SUBJECT:		No: SR-04-004	
TRAILER HITCH WIRING HARNESS — SAFETY RECALL CAMPAIGN		DATE: May, 2004	
		MODEL: See below	
CIRCULATE TO:	<input checked="" type="checkbox"/> GENERAL MANAGER	<input checked="" type="checkbox"/> PARTS MANAGER	<input checked="" type="checkbox"/> TECHNICIAN
<input checked="" type="checkbox"/> SERVICE ADVISOR	<input checked="" type="checkbox"/> SERVICE MANAGER	<input checked="" type="checkbox"/> WARRANTY PROCESSOR	<input checked="" type="checkbox"/> SALES MANAGER

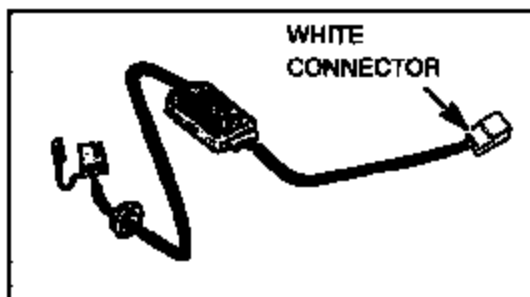
The Mitsubishi Genuine Accessory trailer hitch wiring harness optionally used on affected vehicles may overheat as a result of a high current draw from the trailer lamp circuit. Replace the trailer hitch wiring harness with the new, redesigned harness kit listed in the PARTS INFORMATION section of this bulletin.

1. Verify the trailer hitch wiring harness is the harness shown here. Replace the harness, using the appropriate new parts listed in the PARTS INFORMATION section of this bulletin. Refer to the installation instructions provided with the new harness.
2. Verify the new harness works properly.

Description	Model	Part Number
Trailer Hitch Wiring Harness	Endeavor	AEN04YHX03
Trailer Hitch Wiring Harness	Outlander	ACU03YHX03
